ALERT SERVICE BULLETIN

NO. 430-99-11
DATE 05-07-99
PAGE 1 of 13

MODEL AFFECTED: 430

SUBJECT: AUTOPILOT RESOLVER INSTALLATION,
IMPROVEMENT OF

FIGURE 2

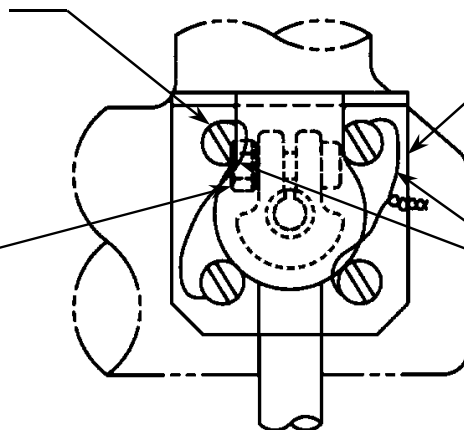
5. At the yaw control synchro resolver, remove the screw, nut and washer securing the yaw control position synchro arm, P/N 430-001-070-103, to the shaft of the yaw control position resolver. (Figure 1 and 2).
6. Move the arm, P/N 430-001-070-103, to allow the removal of the yaw control position resolver.
7. Remove the four screws and eight washers securing the yaw control position resolver to the mounting bracket, and remove the resolver. (Figure 2).
8. Locate the yaw control position synchro arm on the shaft of the yaw control position resolver, and the new guard, P/N 430-001-201-101, in position on the yaw control position synchro mounting bracket.

9. Secure the guard and the control position synchro to the mounting bracket, using qty 4 screws P/N MS35265-13, and qty 8 washers P/N NAS620A4L. Safety the screws, using lockwire (C-508). (Figure 2).

10. Secure the yaw control position synchro arm, P/N 430-001-070-103, to the shaft of the yaw control position resolver, using a screw, P/N NAS1352-04-8P, a washer, P/N NAS620A4L, and a nut, P/N MS21042L04. Torque the screw to a value of 4.5 to 5.5 inch pounds. (Figure 2).

REMOVE: EXISTING SCREW (QTY 4)
 AND WASHER (QTY 8)

INSTALL: NAS620A4L WASHER (QTY 8)
 MS35265-13 SCREW (QTY 4)

REMOVE: EXISTING SCREW,
 WASHER AND NUT

INSTALL: NAS1352-04-8P SCREW
 NAS620A4L WASHER
 MS21042L04 NUT
 APPLY TORQUE OF
 4.5 TO 5.5 IN-LBS

INSTALL:
 430-001-201-101 GUARD

INSTALL:
 AS100026 LOCKWIRE

FIGURE 4

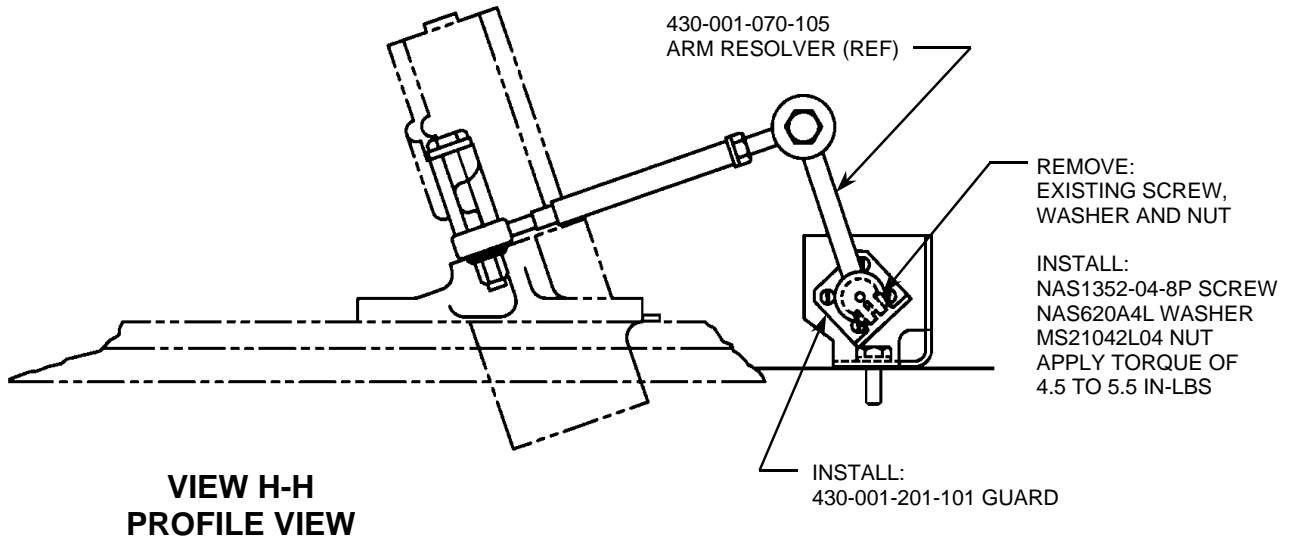
11. At the pitch control synchro resolver, remove the screw, nut and washer securing the pitch control position synchro arm, P/N 430-001-070-105, to the shaft of the pitch control position resolver. (Figure 3 and 4).

12. Move the arm, P/N 430-001-070-105, to allow the removal of the pitch control position resolver. (Figure 4).
13. Remove the four screws and eight washers securing the pitch control position resolver to the mounting bracket, and remove the resolver. (Figure 4).

14. Locate the pitch control position synchro arm on the shaft of the pitch control position resolver, and the new guard, P/N 430-001-201-101, in position on the pitch control position synchro mounting bracket.

15. Secure the guard and the control position synchro to the mounting bracket, using qty 4 screws, P/N MS35265-13 and qty 8 washers, P/N NAS620A4L. Safety the screws, using lockwire (C-508). (Figure 4).

16. Secure the pitch control position synchro arm to the shaft of the pitch control position resolver, using a screw, P/N NAS1352-04-8P, a washer, P/N NAS620A4L, and a nut, P/N MS21042L04. Torque the screw to a value of 4.5 to 5.5 inch pounds. (Figure 4).

FIGURE 5
MODIFICATION OF ROLL CONTROL
POSITION RESOLVER

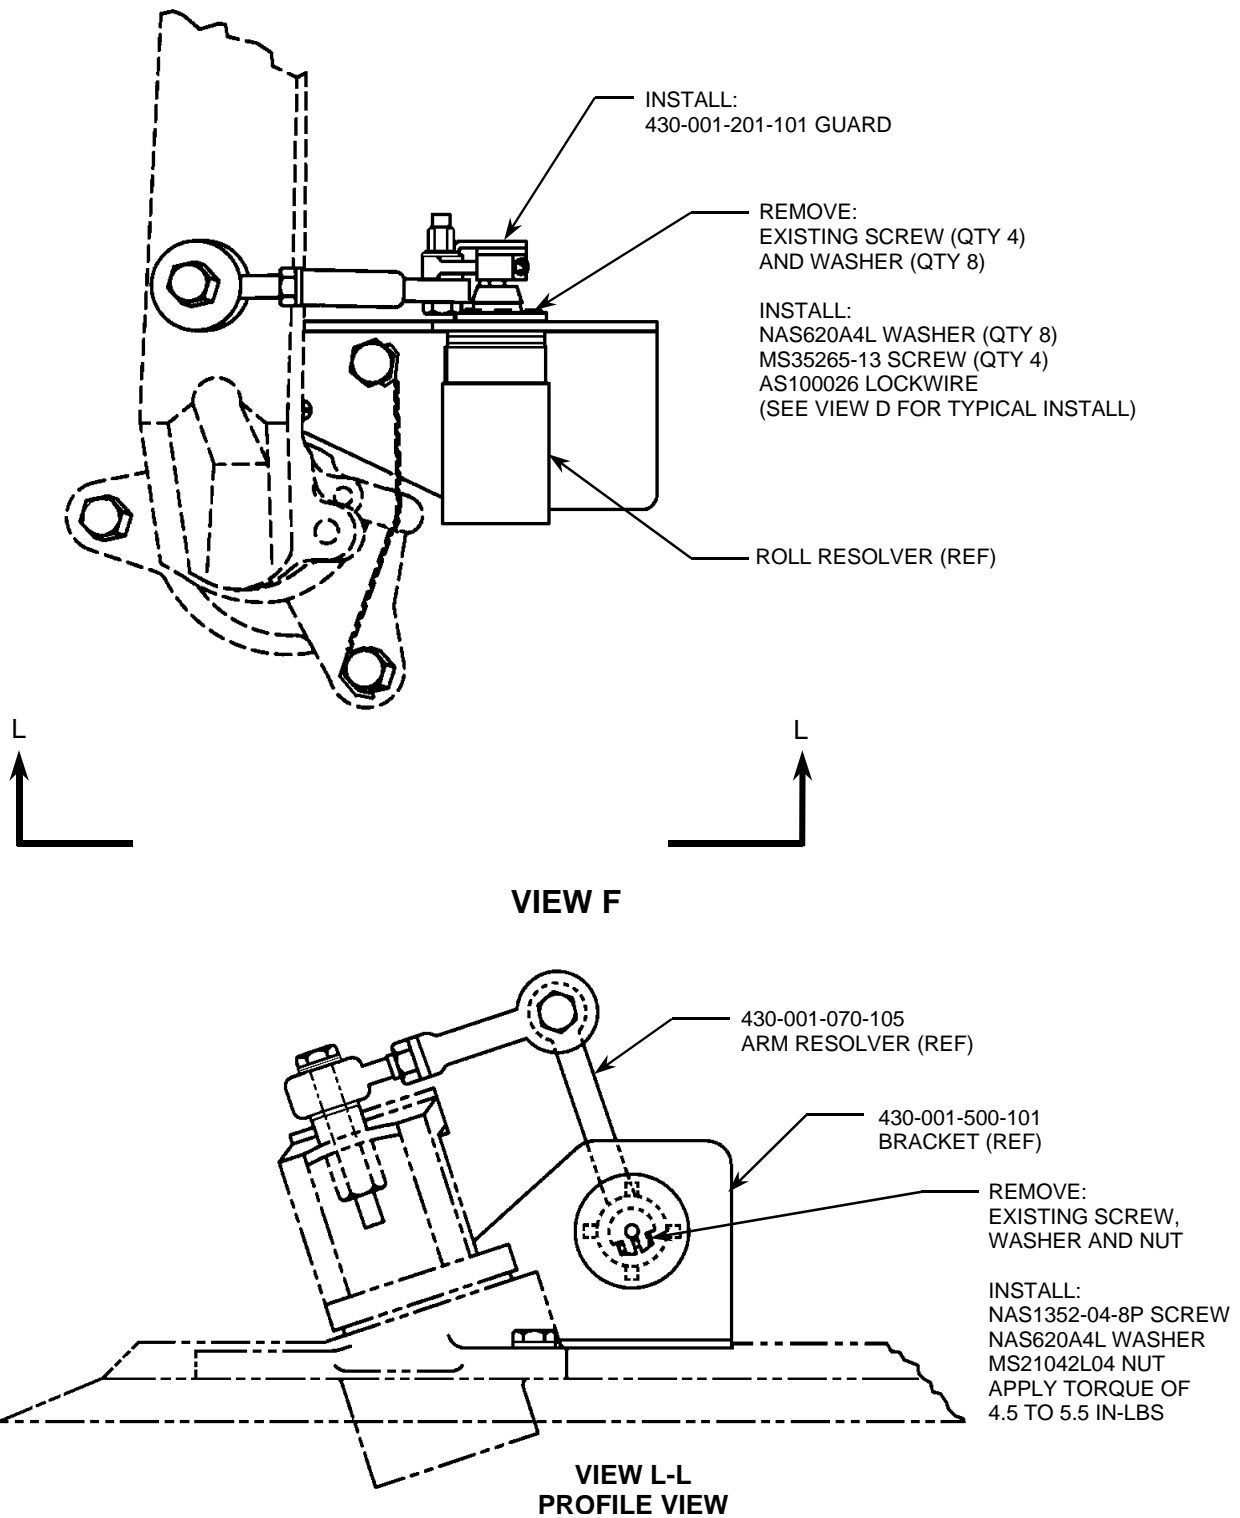
17. At the roll control synchro resolver, remove the screw, nut and washer securing the roll control position synchro arm, P/N 430-001-070-105, to the shaft of the roll control position resolver. (Figure 3 and 5).

18. Move the arm, P/N 430-001-070-105, to allow the removal of the roll control position resolver (Figure 5).
19. Remove the four screws and eight washers securing the roll control position resolver to the mounting bracket, and remove the resolver. (Figure 5).

20. Locate the roll control position synchro arm on the shaft of the roll control position resolver, and the new guard, P/N 430-001-201-101, in position on the roll control position synchro mounting bracket.

21. Secure the guard and the control position synchro on the mounting bracket, using qty 4 screws, P/N MS35265-13 and qty 8 washers, P/N NAS620A4L. Safety the screws, using lockwire (C-508). (Figure 5).

22. Secure the roll control position synchro arm to the shaft of the roll control position resolver, using a screw, P/N NAS1352-04-8P, a washer, P/N NAS620A4L, and a nut, P/N MS21042L04. Torque the screw to a value of 4.5 to 5.5 inch pounds. (Figure 5).

FIGURE 6
MODIFICATION OF COLLECTIVE CONTROL
POSITION RESOLVER

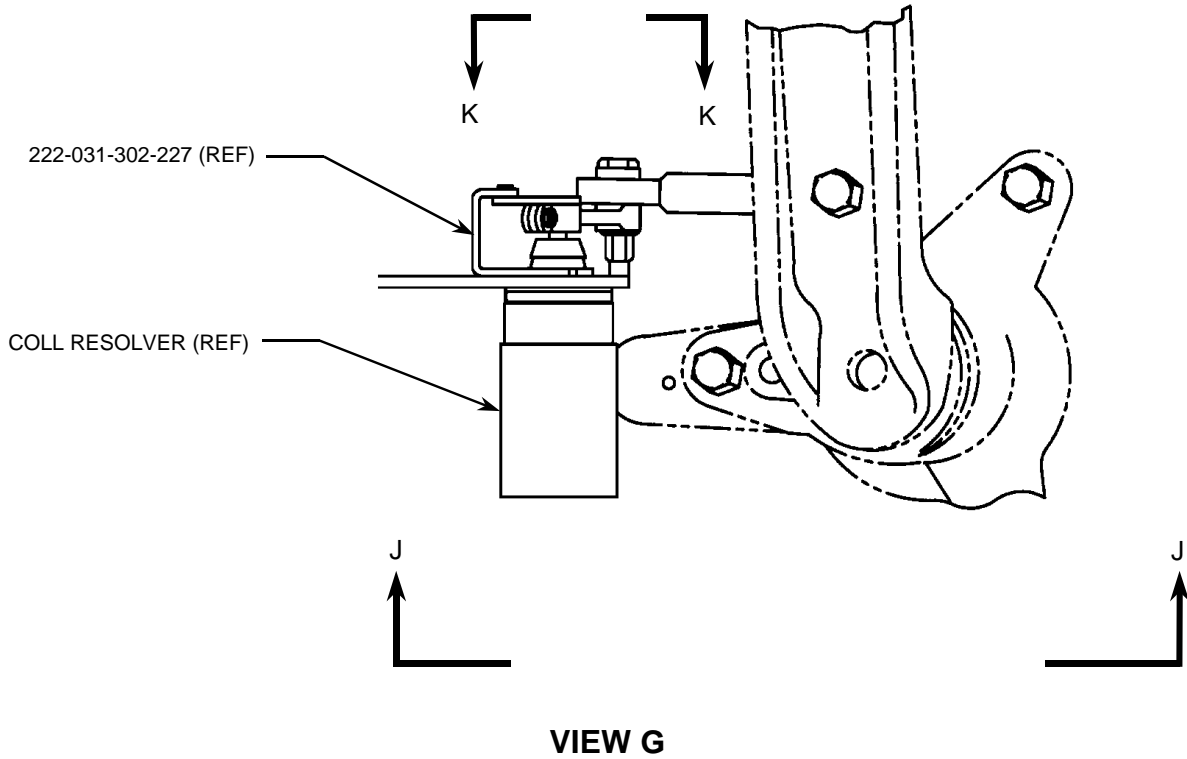
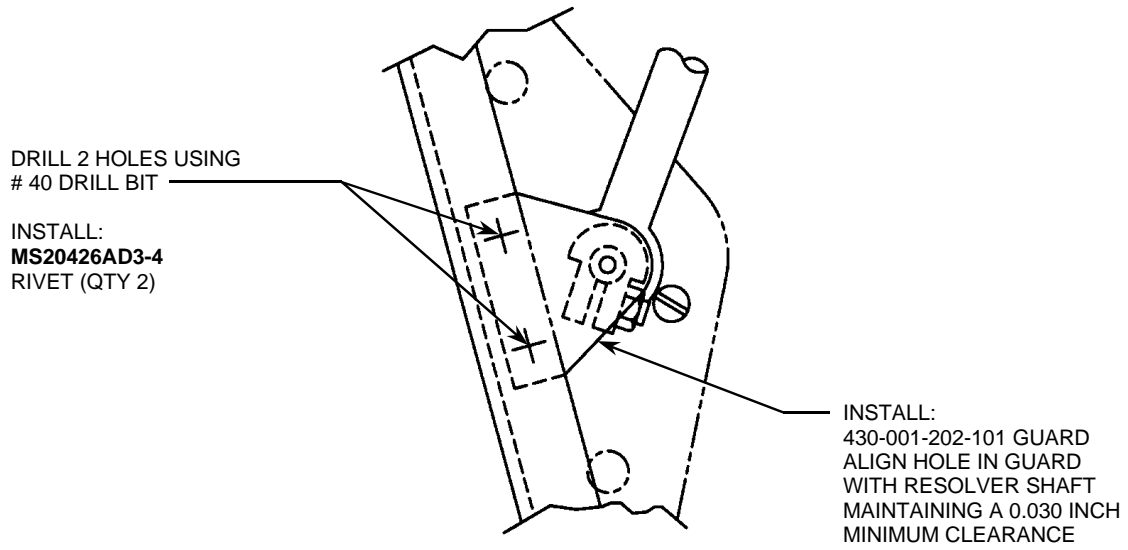
23. At the collective control synchro resolver, remove the screw, nut and washer securing the collective control position synchro arm to the shaft of the collective control position resolver. (Figure 6).

24. Secure the collective control position synchro arm to the shaft of the collective control position resolver, using a screw, P/N NAS1352-04-8P, a washer, P/N NAS620A4L, and a nut, P/N MS21042L04. Torque the screw to a value of 4.5 to 5.5 inch pounds. (Figure 6, View J-J).

25. Locate the new collective control position synchro guard, P/N 430-001-202-101, in position on the support, P/N 222-031-302-227. Align the hole in the guard with the resolver shaft, maintaining a 0.030 inch minimum clearance. Using a #40 drill bit, drill qty 2 holes through the guard and support, allowing sufficient edge clearance. (Figure 6, View K-K).

26. Attach the guard to the beam using 2 rivets, P/N MS20426AD3-4. (Figure 6, View K-K).
27. Carry out the setup installation procedure for the pitch, roll, yaw and collective position synchros. (BHT-430-MM-3, Chapter 22).
